SUBJECT: NRC REQUIREMENTS FOR AUXILIARY FEEDWATER SYSTEMS AT HADDAM NECK  
NUCLEAR POWER PLANT

HADDAM NECK

AUXILIARY FEEDWATER SYSTEM

Auxiliary Feedwater System  
Haddiam Neck  
Figure 1

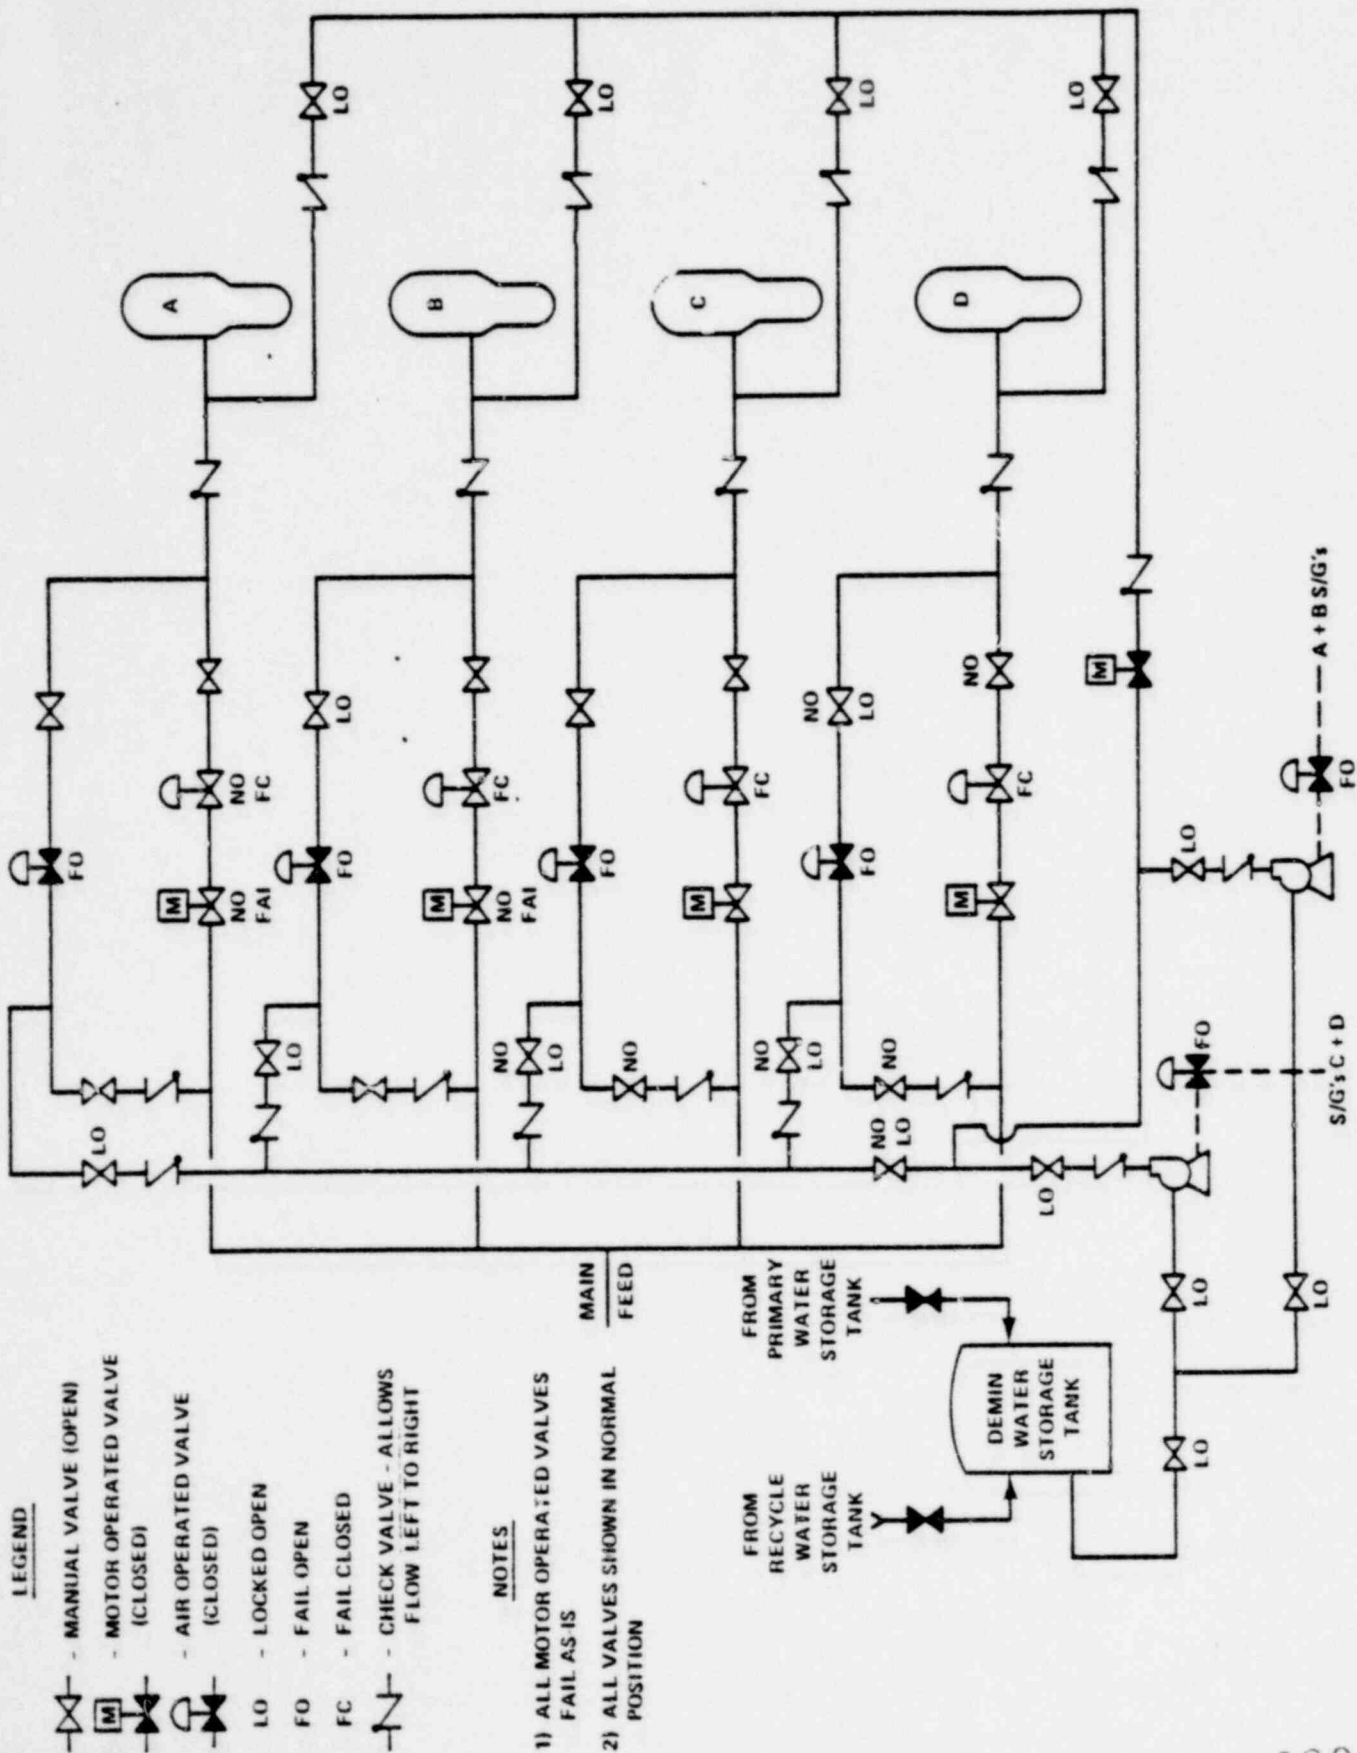
1. Recommendation - GL-2 - Licensees with plants in which all (primary and alternate) water supplies to the AFW systems pass through valves in a single flow path should install redundant parallel flow paths (piping and valves).

Licensees with plants in which the primary AFW system water supply passes through valves in a single flowpath, but the alternate AFW system water supplies connect to the AFW system pump suction piping downstream of the above valve(s), should install redundant valves parallel to the above valve(s) or provide automatic opening of the valve(s) from the alternate water supply upon low pump suction pressure.

3. Recommendation - There is a common crossconnect line with no isolation valves between the two parallel flow paths on the S/G's. A break in this section cannot be isolated in the present design and the total system would be unavailable. It is recommended that some modifications be made (such as isolation valves) to provide isolation when necessary and assure a means of supplying AFW flow following isolation of such a break. The licensee has begun design plans to add a motor driven pump to the system. The licensee should introduce the flow from this third pump in such a manner that a break in this crossconnect

line will not result in the loss of all pumps. Also the licensee should 1) install the third pump with appropriate valves in the pump discharge line connections to meet the high energy line break criteria in SRP 10.4.9 and Branch Technical Position ASB 10-1; namely, to maintain the capability to supply the required AFW flow to the steam generators with a postulated pipe break anywhere in the AFW pump discharge lines plus a single active failure, or 2) describe how the plant can be brought to a safe shutdown condition by use of other available systems following such a postulated event.

4. The AFW system itself is not designed to withstand a passive failure at all points within the system. A pipe break in a normally pressurized portion of the AFW system can be isolated by operation of manual valves outside the control room. An alternate flow path to all four S/G's would be available following such isolation. The motor driven main feedwater pumps may also be available in this event since no transient should result to cause a loss of non-vital power. For the same reasons, the main feed pumps may also be available following a break in any portion of the AFW system that is not normally pressurized even though the AFW system could be disabled. Further review, including the main feedwater system and time available for operator action, should be conducted to determine if this design has protection equivalent to today's requirements (pipe break
